AMENDMENTS TO THE DRAWINGS

REMARKS/AMENDMENTS

This paper addresses the issues raised in the Office Action mailed August 31, 2005. This amendment is submitted in compliance with the guidelines of the revised amendment practice. See 1267 Off. Gazette 106.

U.S. Serial No. 10/717,114
Amdmt dated November 23, 2005
Reply to OA of August 31, 2005
Annotated Sheet

FIG. 8B

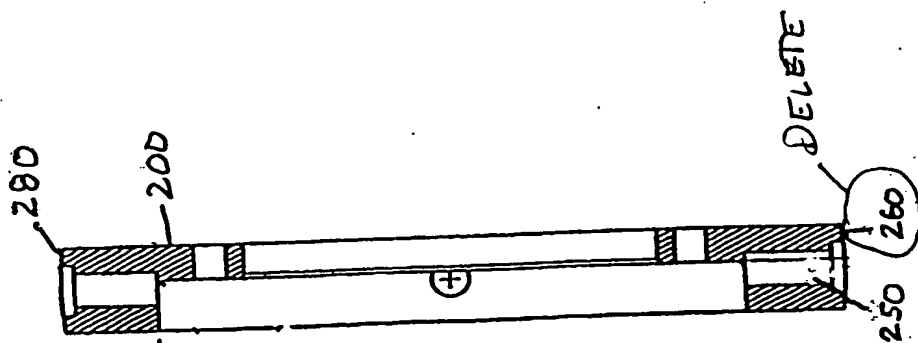
In the Office Action, the Examiner objected to drawings, specifically to FIG. 8B due to projection 260 apparently pointing to something other than a projection. A corrected drawing sheet is attached to this response amended FIG. 8B such that reference numeral 260 has been removed therefrom. Reconsideration is respectfully requested.
